Flood Map Update

MR106 Deansgrange

| DOCUMENT TITLE | Flood Map Update - Deansgrange |

Figure 1: The CFRAM modelled river centerline (magenta) and the actual watercourse alignment (green) near Little Meadow

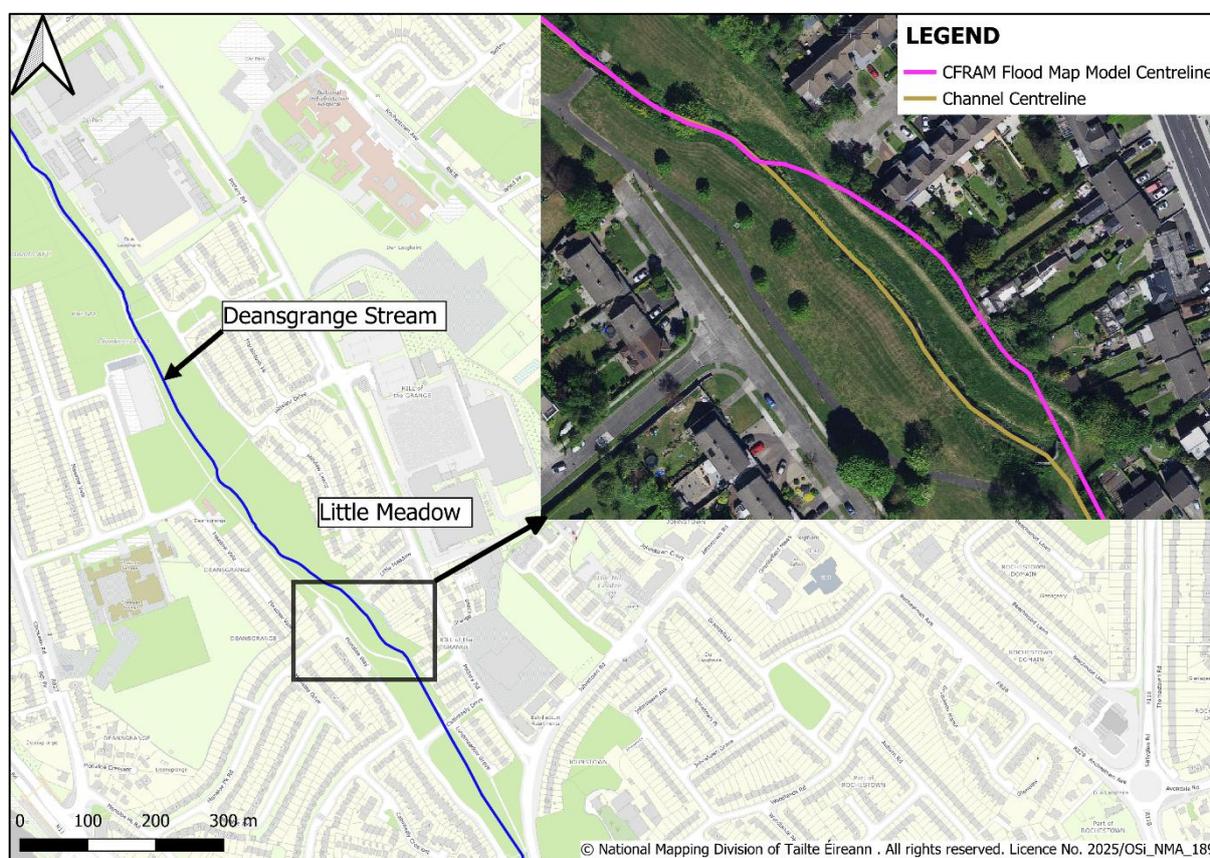
A Flood Map Review Request was received by the OPW which indicated a potential anomaly in the flood mapping regarding the modelled river centreline of the Deansgrange Stream. As shown in Figure 1, the Deansgrange Stream modelled river centreline shown on the CFRAM flood map is not matching the actual alignment of the river channel in the area of Little Meadow.

It was determined that the modelled river centerline for the Deansgrange Stream near Little Meadow in the final CFRAM flood maps was the incorrect version. It was also determined that the flood alleviation works were incorporated into the final CFRAM hydraulic model and therefore the label shown in Figure 2 was not necessary.

The flood alleviation works at Little Meadow were included in the final CFRAM hydraulic model and Flood Maps. Therefore, the modelled river centerline was amended on the Flood Maps to follow the actual channel alignment, as shown in Figure 1. The label displayed on the flood depth maps, as shown in Figure 2, was removed as it was not necessary.

Figure 2: Label shown on CFRAM Depth Maps E10LOU_DPFCD001_F1_08

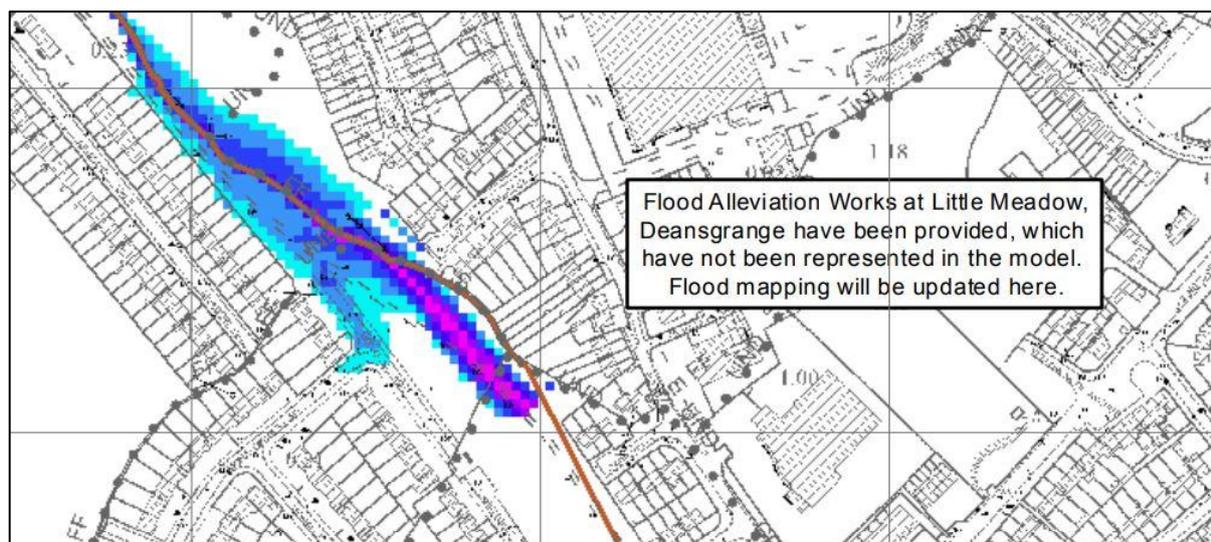
The Flood Map Review Request also queried a label displayed on the CFRAM flood depth maps suggesting the flood alleviation works at Little Meadow, Deansgrange have not been represented in the model yet. See Figure 2 below.
